SUBJECT: MIDLAND DIESEL GENERATOR BUILDING (DGB)

Subject: Visual Aids for April <sup>24</sup>~~25~~, 1984 Meeting w/ R. Vellmer, J. Keppeler and D. Essenhut (2:00 pm in D. Essenhut's office)

ADDITIONAL REQUIREMENTS FOR DGB EVALUATION

### Request for Additional Information Regarding Structural Adequacy of Midland Diesel Generator Building

FIGURE DGB-4  
DIESEL GENERATOR BUILDING  
DUCT BANK LAYOUT

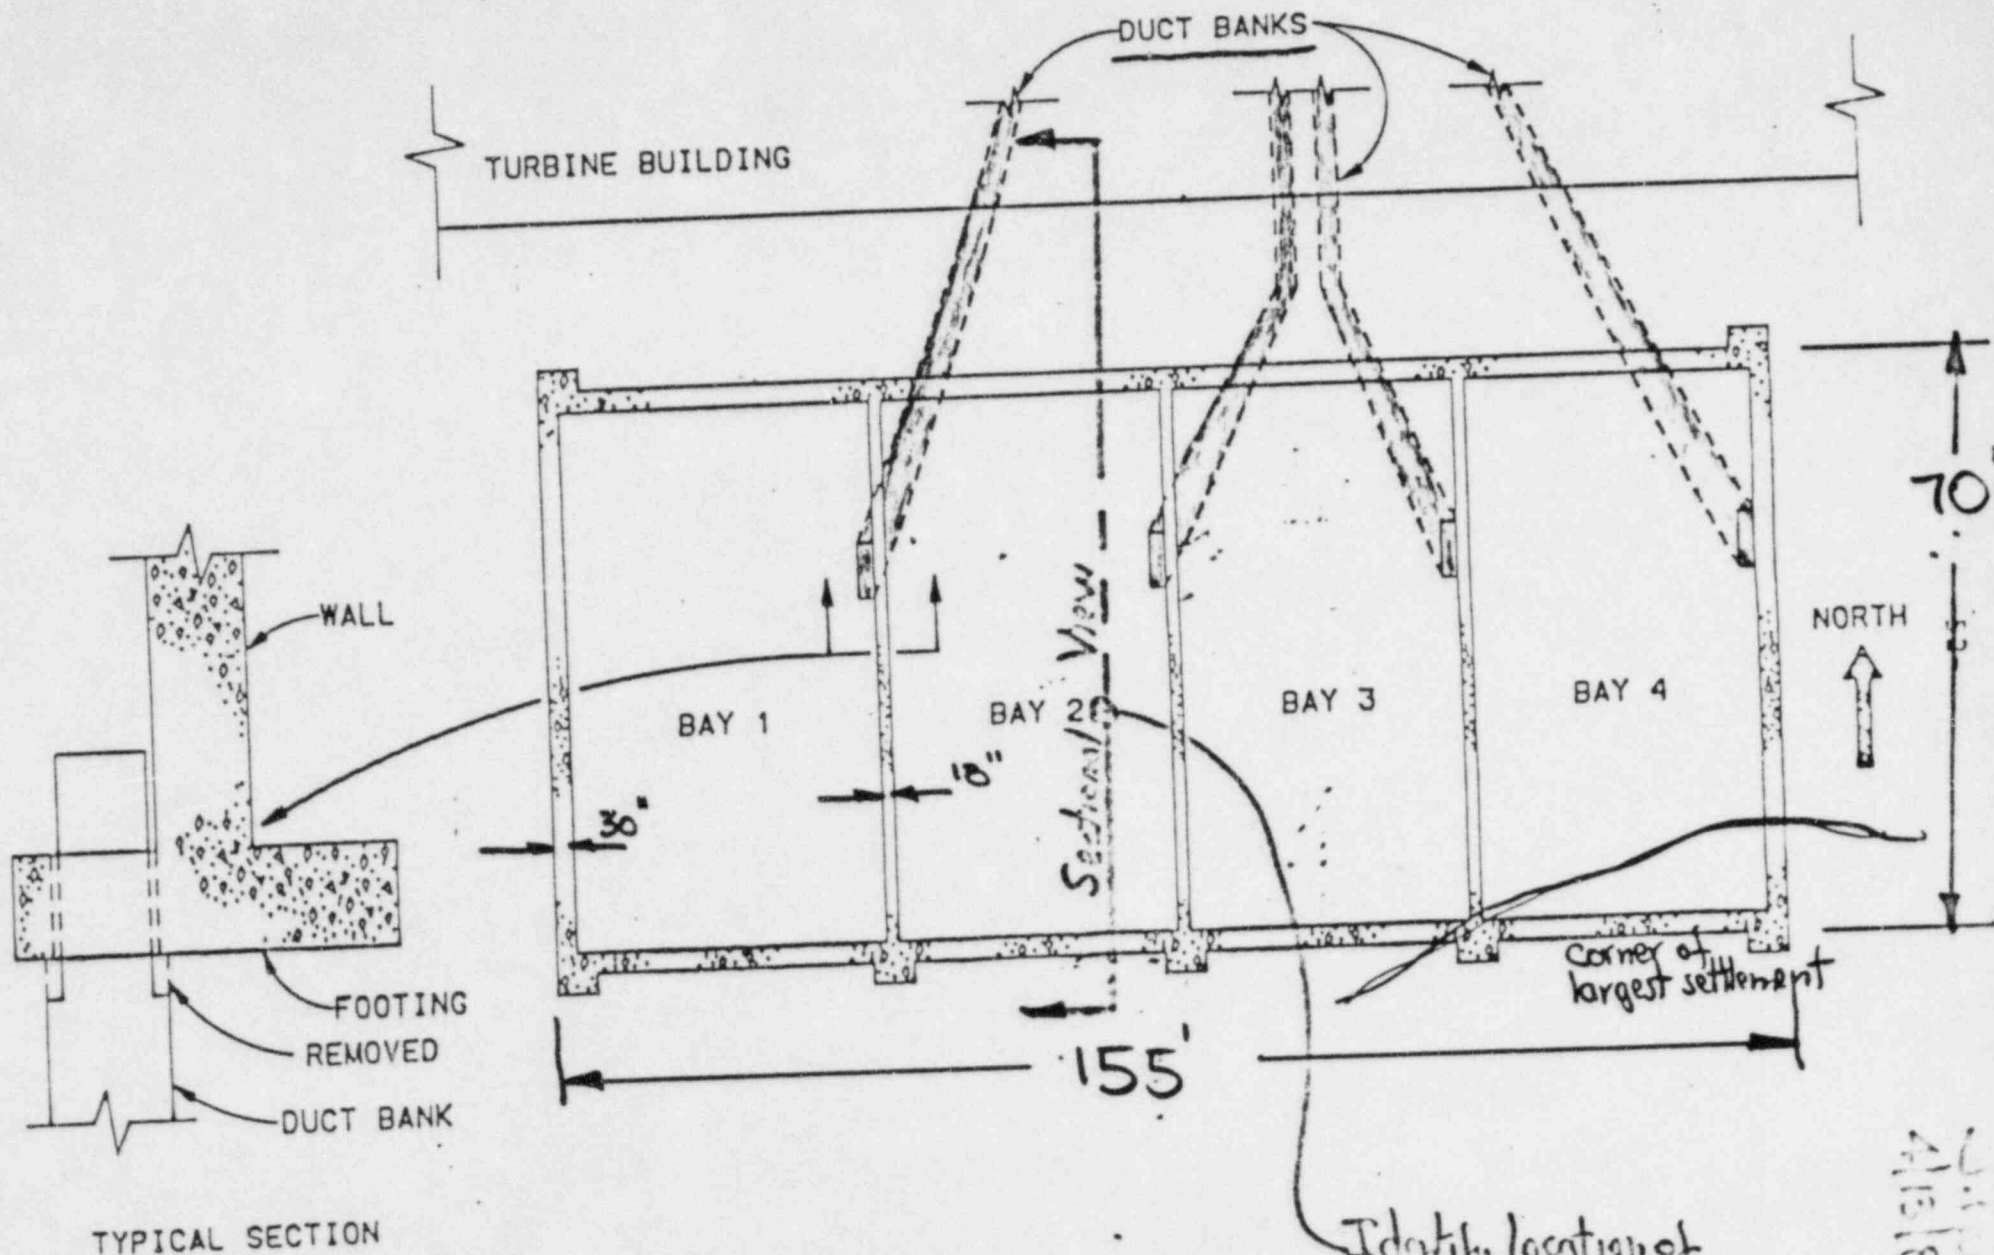
- Viewgraph 1 DGB Plan View - Show the following features:
- Overall dimensions, 155' x 70'
  - North - Turbine Building
  - 4 Bays - 30" Exterior Walls, 18" Interior Walls
  - Corner of largest settlement - Settlement from
  - Duct banks from Turbine Bldg area beneath DGB
  - Show location of sectional view for NEXT viewgraph

FIGURE DGB-5  
DIESEL GENERATOR BUILDING DUCT BANK ELEVATION  
(Surcharge Also Shown)

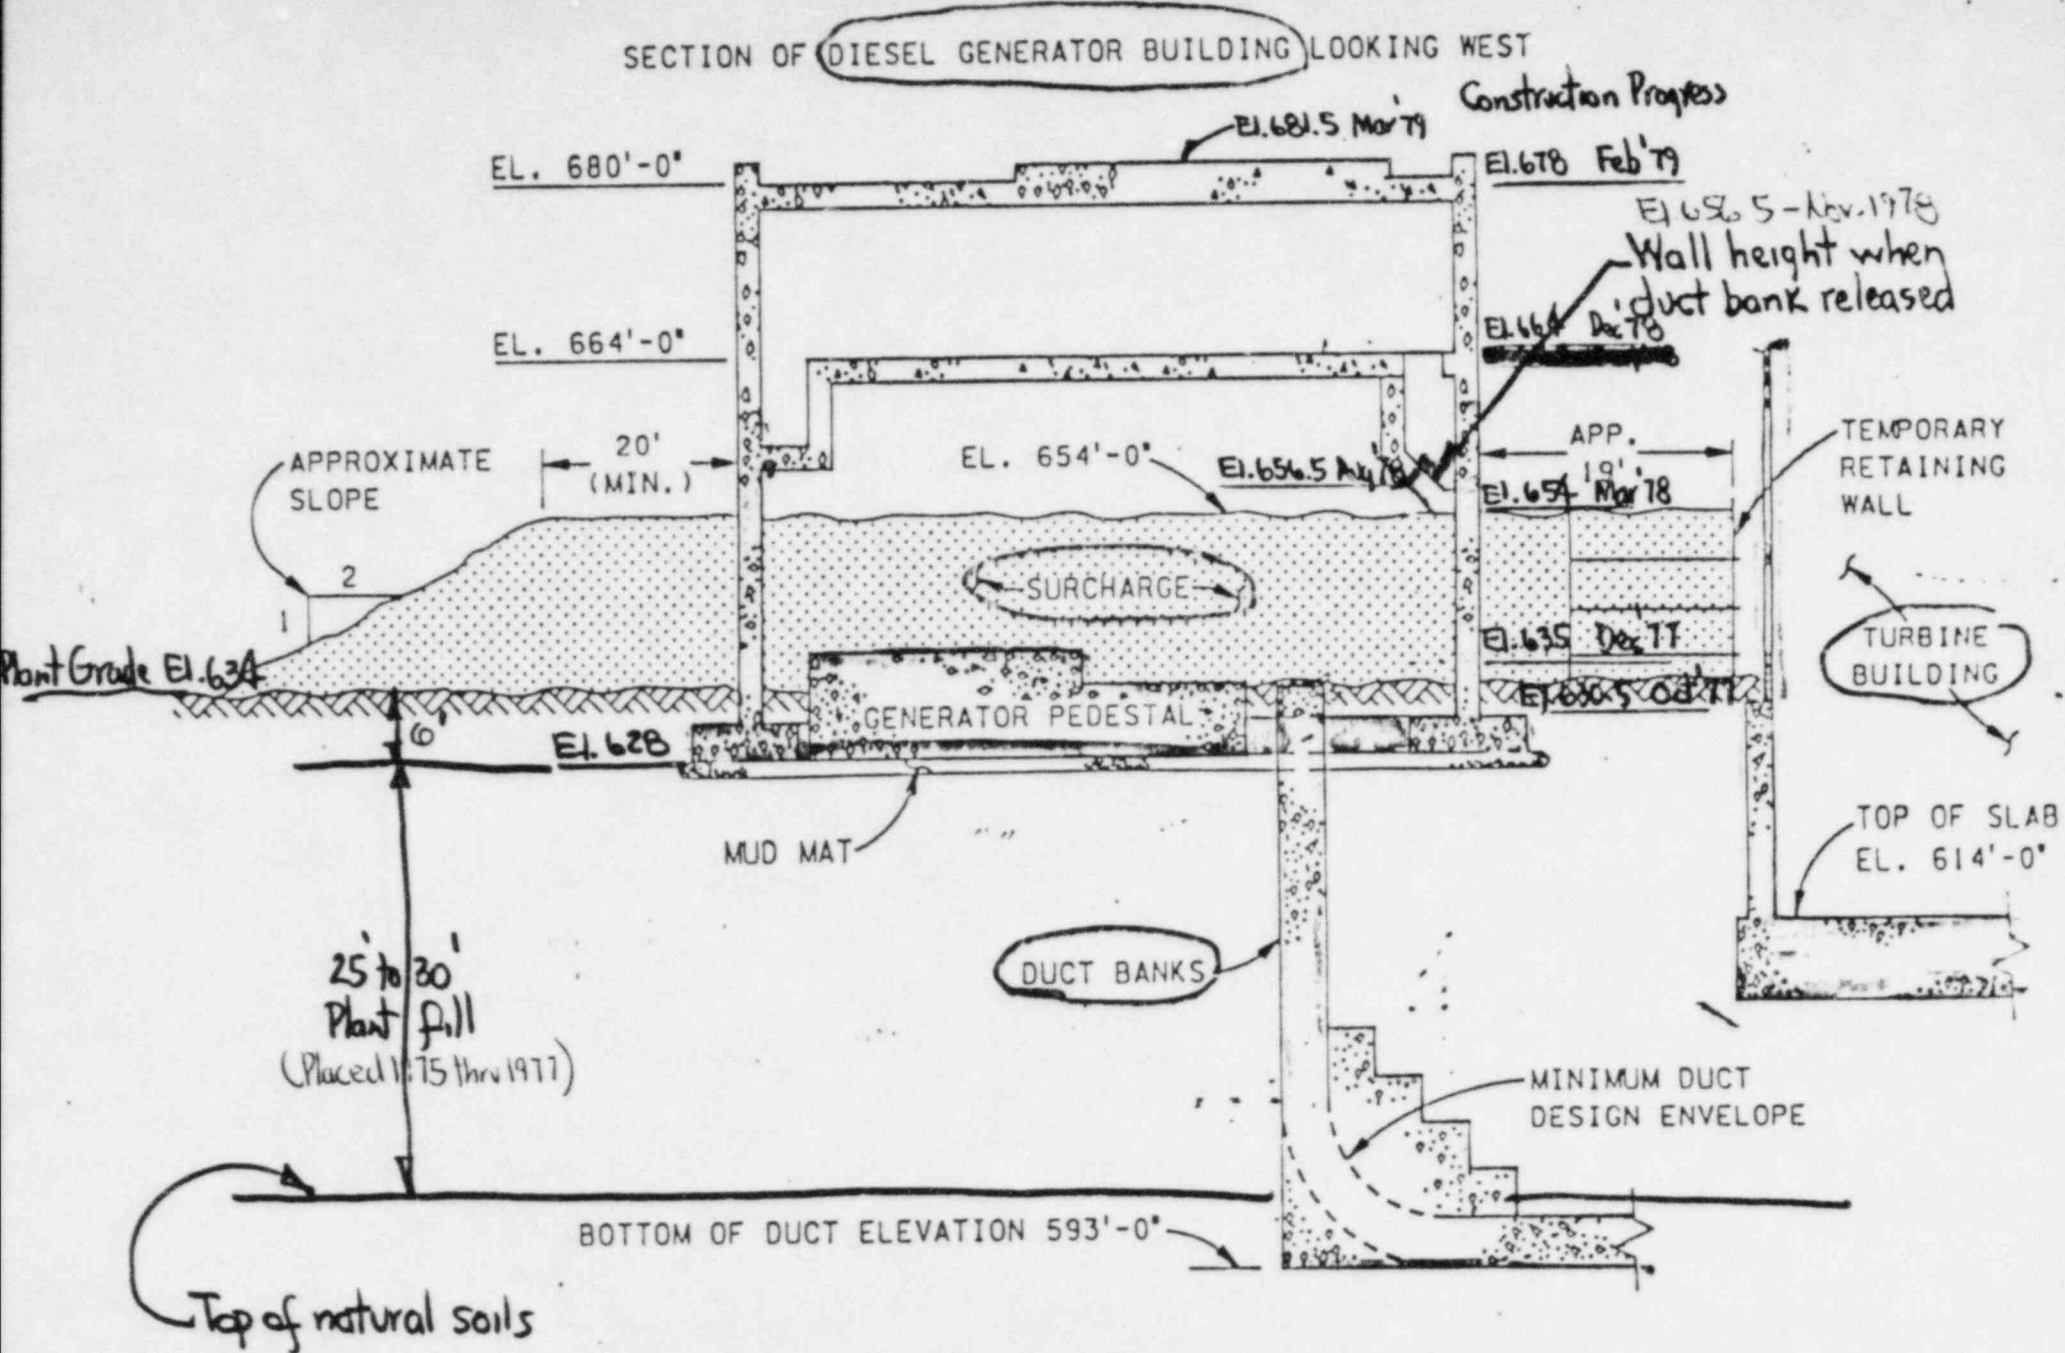
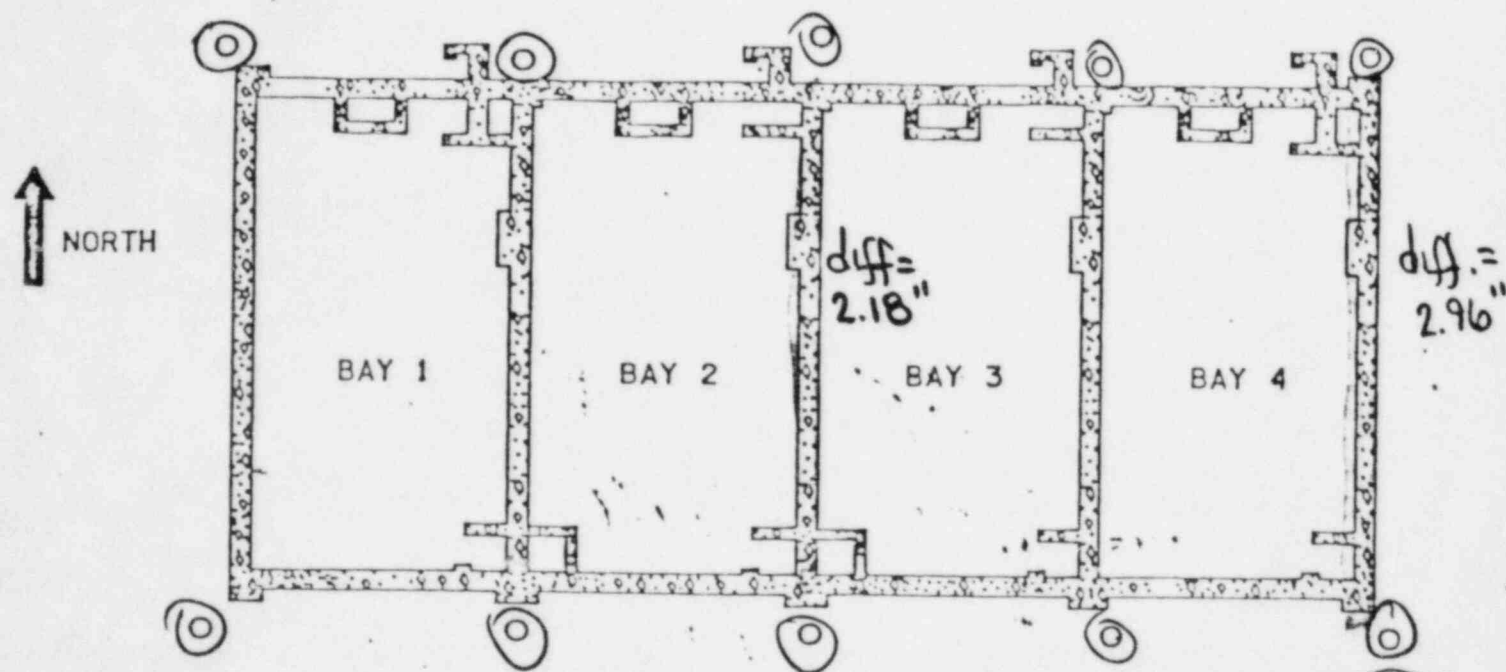
- Viewgraph 2 DGB Sectional View - Show the following features:
- DGB walls, floor slabs, pedestals & continuous wall footing
  - Foundation conditions - 25' to 30' of plant fill over natural soil
  - \* - Vertical duct bank from natural soil. Hung up & release
  - Surcharge Program - Placing 20' of Sand Fill - Completion of Building
  - Important Elevations Plant Grade El 634, Footings @ El 628

**FIGURE DGB-7**  
 SUMMARY OF ACTUAL AND ESTIMATED SETTLEMENTS  
**DGB Settlement History**

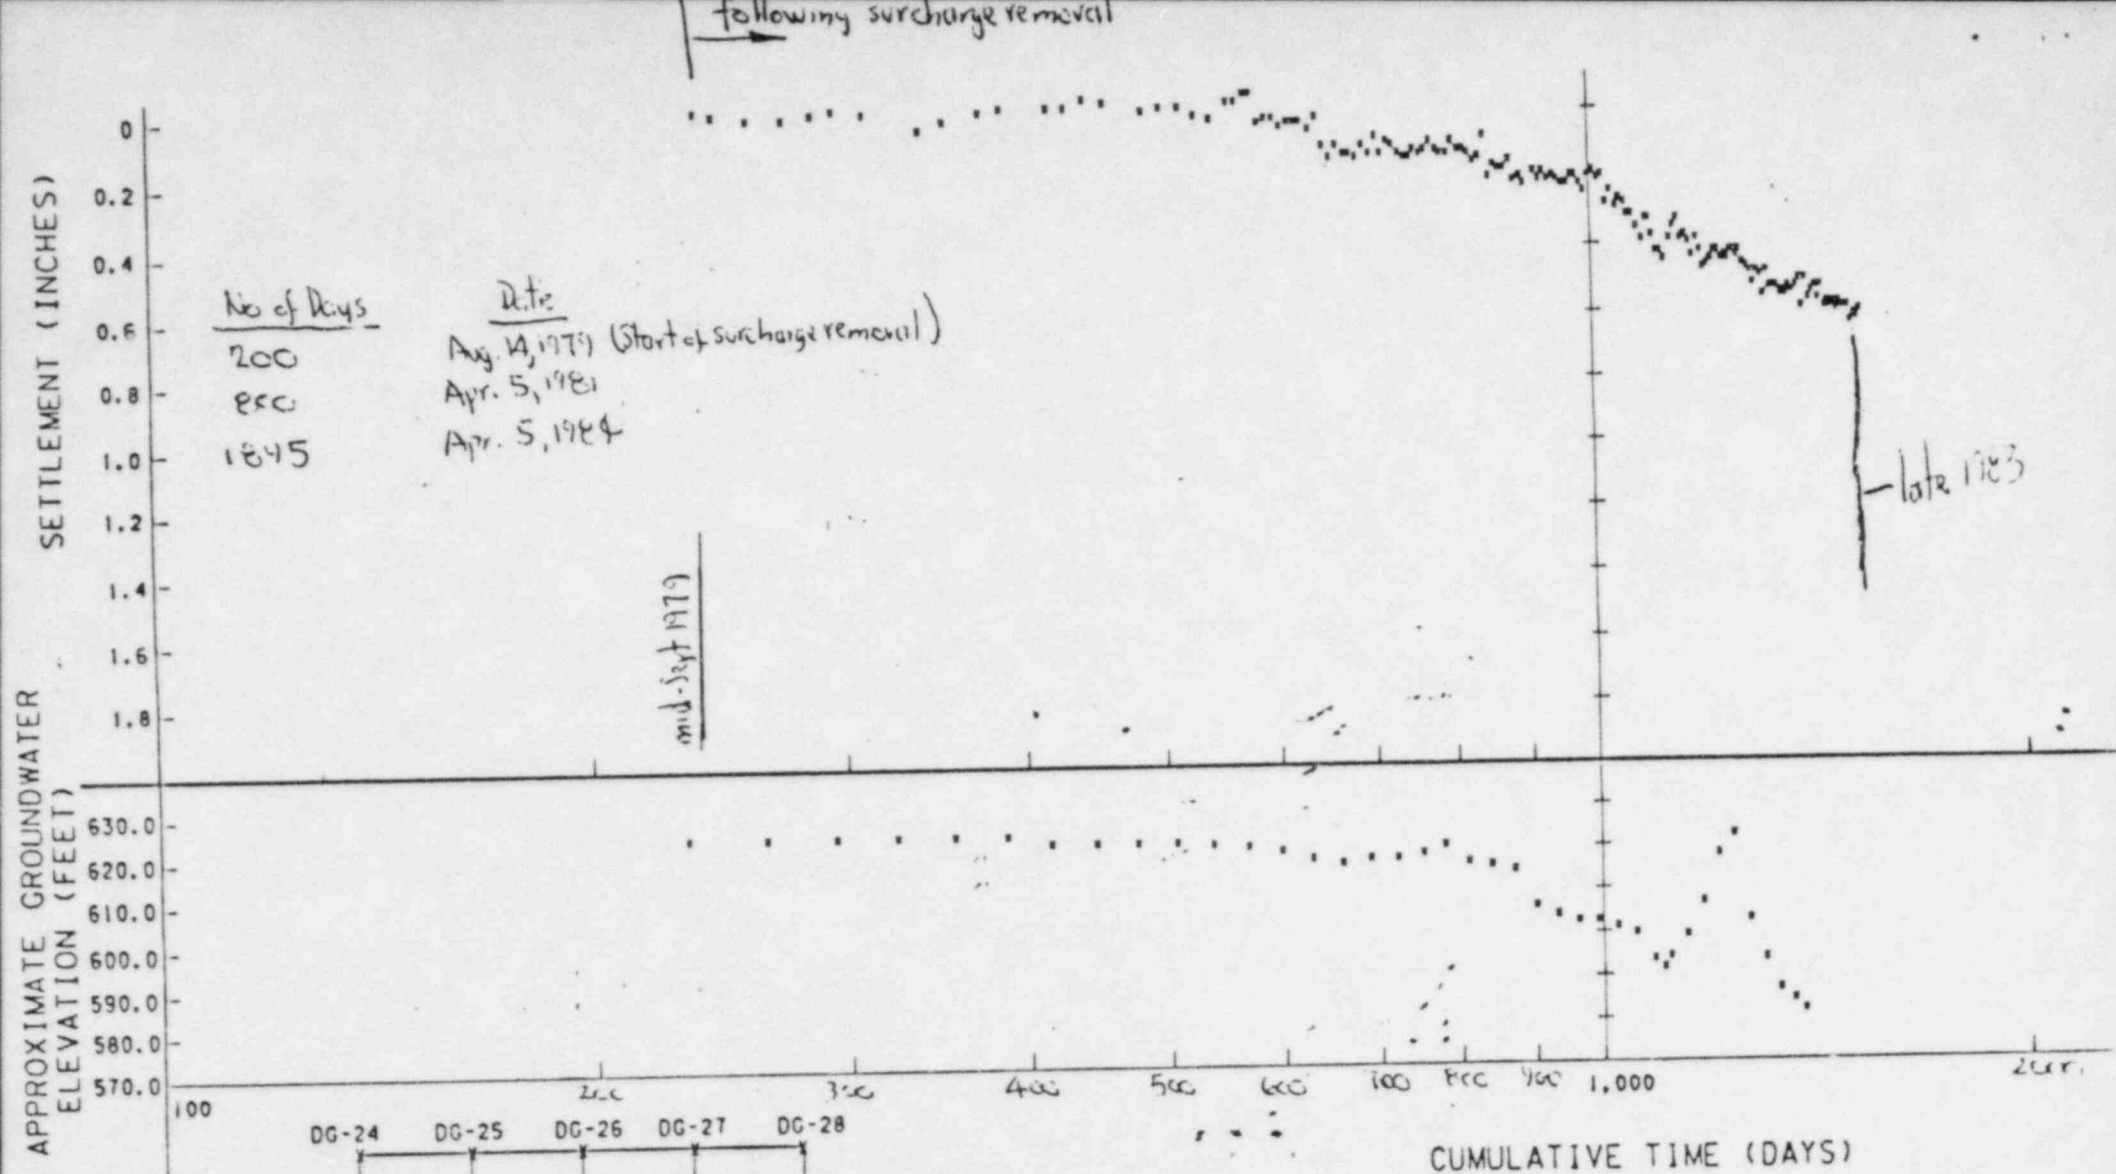
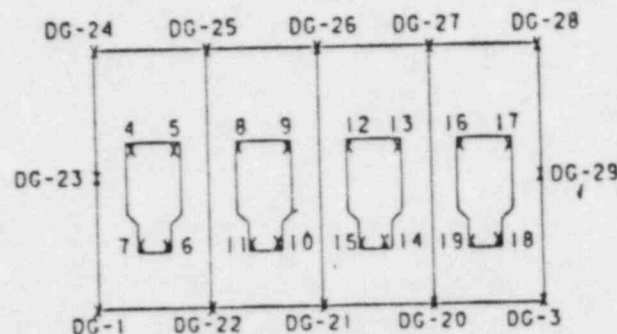
- Location of 28 Settlement Markers - Surveyed since Mar. 1978 (DCB walls in Mar. 78 @ El 654). Survey readings to 1/1000 ft. and data plotted to 1/1000 inch
- Vugraph summarizes DCB settlements at 10 wall locations. The summary consists of both actually measured settlements (up to Dec 81) and estimated future settlements (to the year 2025).
- Take southeast corner (DG-3) and explain correlation between settlement increment and time period
- Indicate settlement patterns  along South wall and East wall.
  - Max. total settlement is 9.33"
  - Max. Differential settlement along N-S trending wall is  $\approx 2"$  (center)  $\approx 3"$  (East wall)

\* The settlement values listed on this Vugraph are the values which the Applicant and Staff ultimately agreed are appropriate for use in structural analysis of the DCB.

*Relate time periods to construction status to previous sectional view*
